Informal document **GRE-83-41**  
83rd GRE, 19-23 October 2020,  
agenda item 6 (b)

### **Comments on ECE/TRANS/WP.29/GRE/2020/8/Rev.1**

This document includes Polish comments to document (in RED and GREEN for support), basically to mistakes and inconsistencies in justification. Poland many times in many documents proposed improvements of proposal which are still valid.

**UN Regulation No. 48 (Installation of lighting and light-signalling devices):****Proposals for new series of amendments to UN Regulation No. 48****Revised proposal for a new [0x] series of amendments to UN Regulation No. 48****Submitted by the Informal Working Group on Simplification of Lighting and Light-Signalling Regulations\***

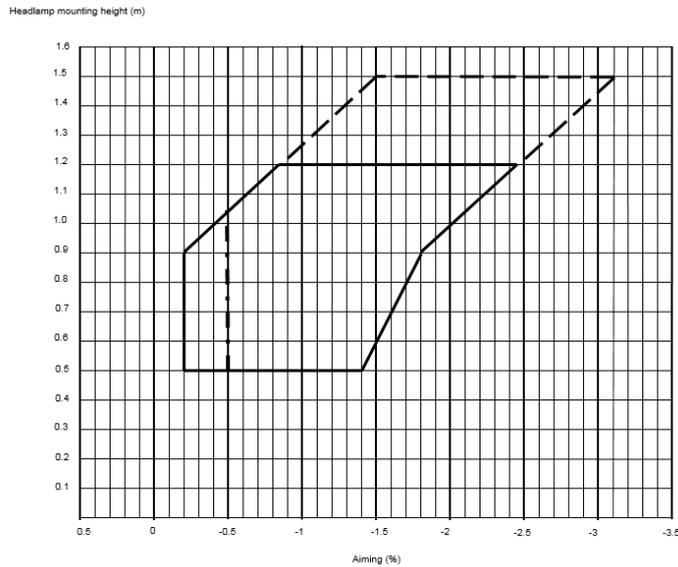
Above is not consistent with all boundaries of box – rest of glare line and whole road illumination line. PTI – in fact the garage aiming procedure using headlight tester – should be added for whole lines on left and right side of graph because garage aiming procedure influence as well glare as minimum road illumination distance for any height. See SLR-35-15.

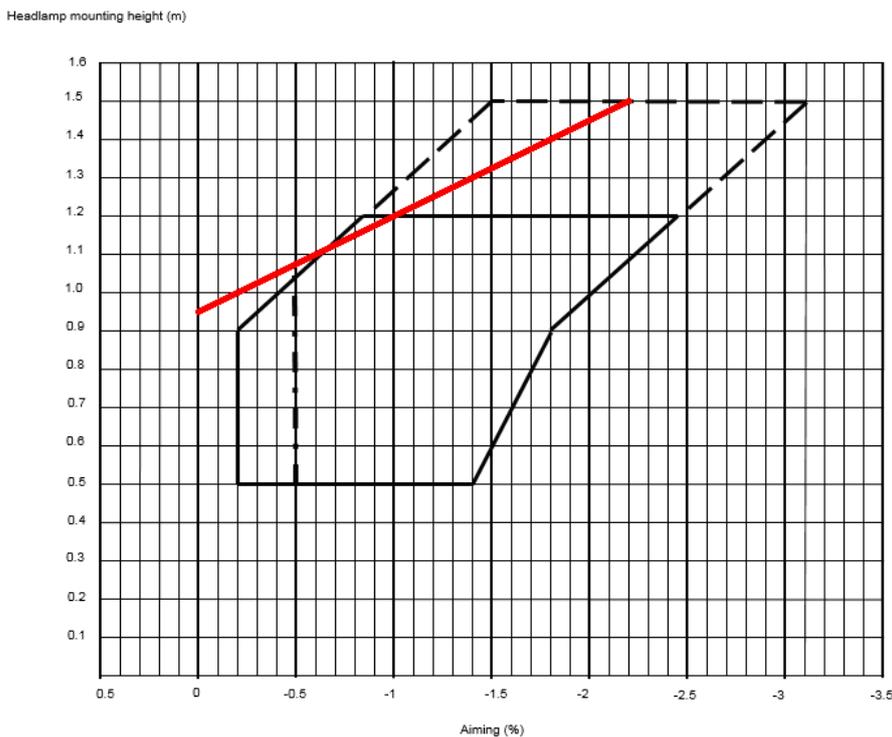
Mistake! Above (yellow marked) justification is proper one but line described by above justification (document VGL-10-03 , sheet 13) is the red line in graph below. The black and dashed slant left line has no scientific/research/common sense justification.

Red line described above (VGL-10-03, sheet 13) is the guarantee for glare protection beyond 25 m from 0.95m up to any height (1.5m). Proposed artificially prolonged (black) line will cause high glare in longer distances. It has nothing to Klettwitz tests because heights over 1.0 m were not tested.
